ADDENDUM NO. 1

N Cass Signal and Intersection Improvements
Project #23-389-201

Addendum No. 1 - Questions and clarification.

Sheet 9 of 22

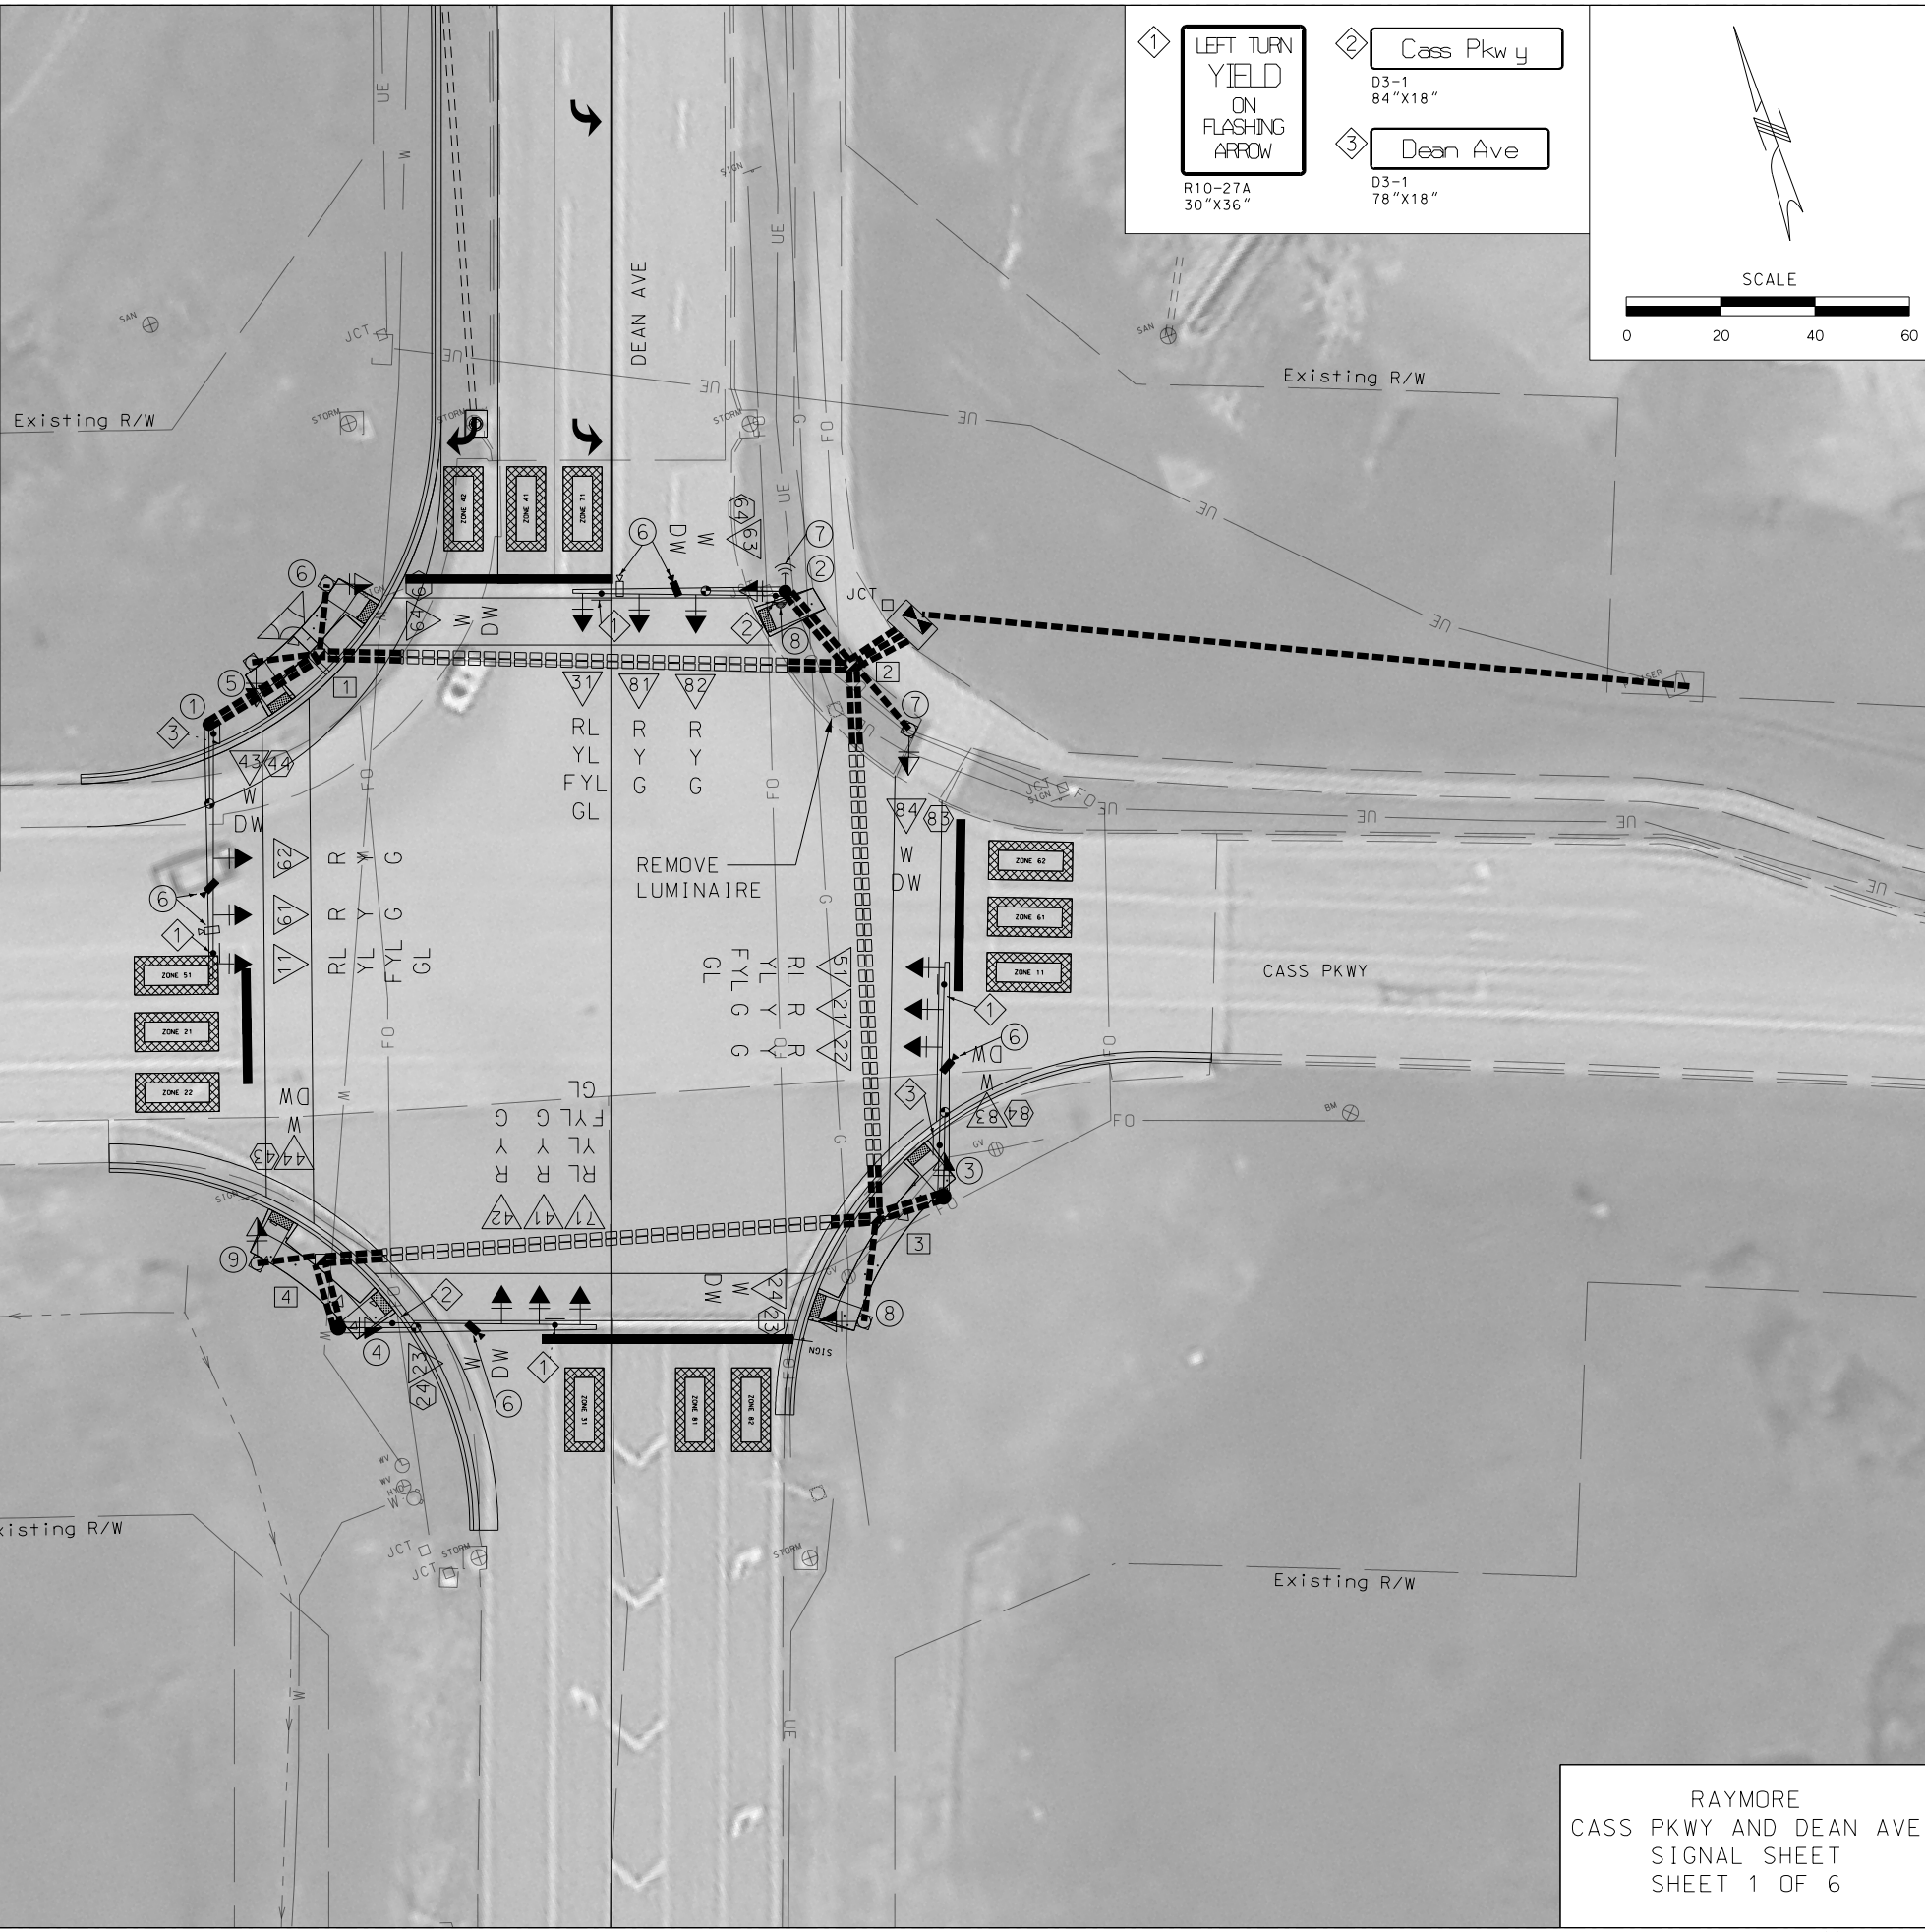
- a. Plan sheet 9
 - i. Moved CCTV camera from signal pole 2 mast arm to preferred location on signal pole 2.
- b. Plan Sheet 11
 - i. Added remarks for jumper cable quantities.
 - ii. Revised 7C #16 cable quantities, total revised from 1884 feet to 1896 feet, noted jumper cables.
 - iii. Revised detector cable quantities from 1244 feet to 1274 feet.
 - iv. Revised ground wire cable quantity from 701 feet to 1215 feet. Added note that all conduit and pull boxes shall have 1C #6 Ground Wire.
- c. Plan Sheet 13
 - i. Revised labels and leaders on cable conduits in NW corner of intersection from Pull Box 1 to poles 1, 5, and 6.
 - ii. Revised video (detection) cables for detector locations as depicted in the plans.

RAYMORE
CASS PKWY AND DEAN AVE
WIRING DIAGRAM
SHEET 5 OF 6

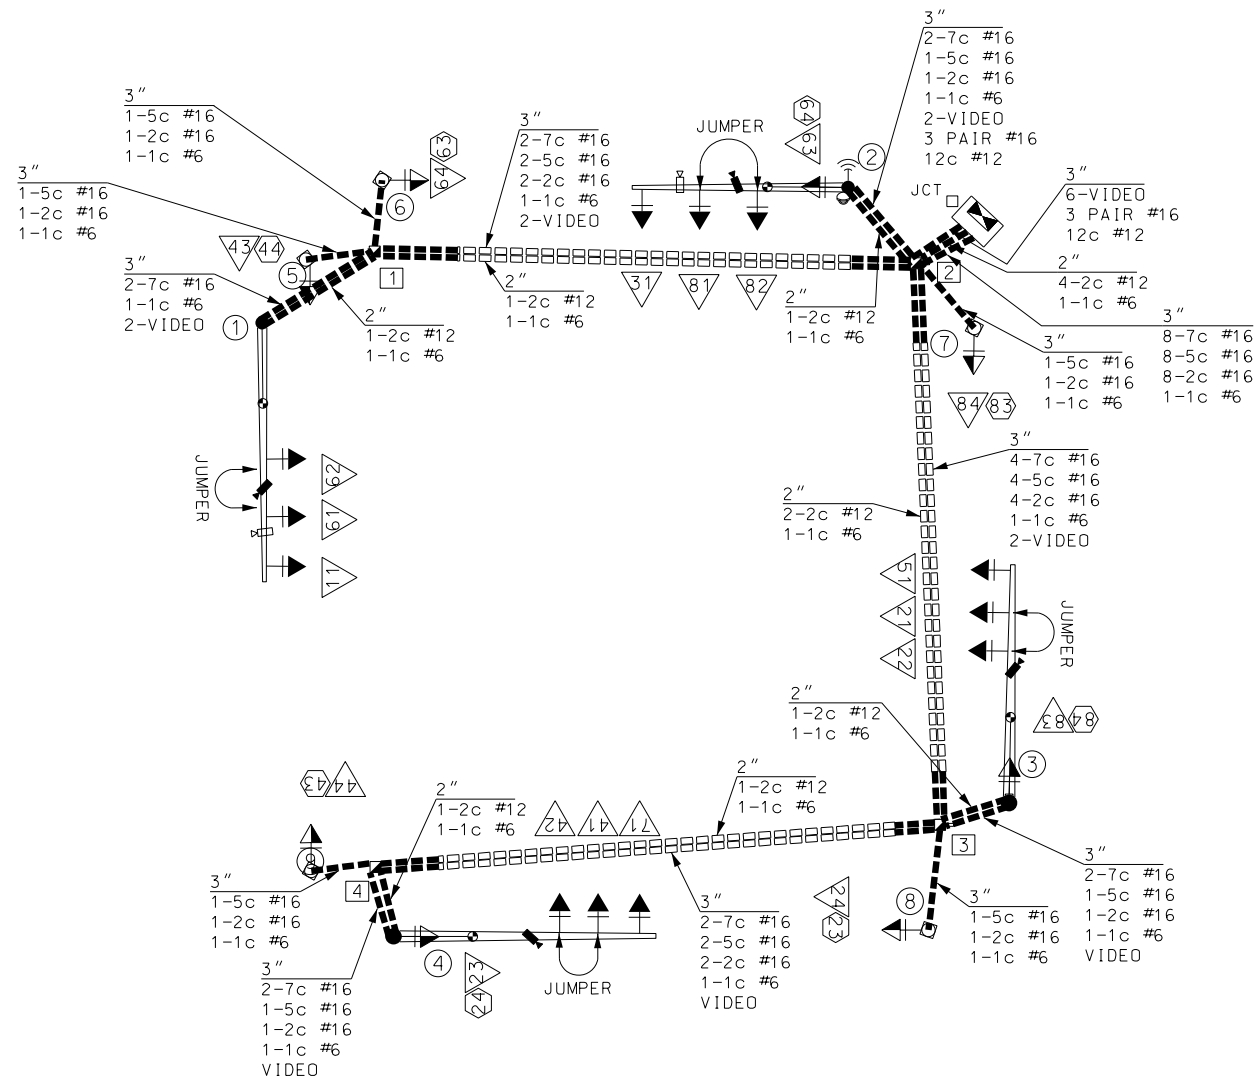
9. Clarification: Discrepancies on the wiring for pole 1 and pole 5. Please clarify.

Response: Please see revised plan sheet(s).
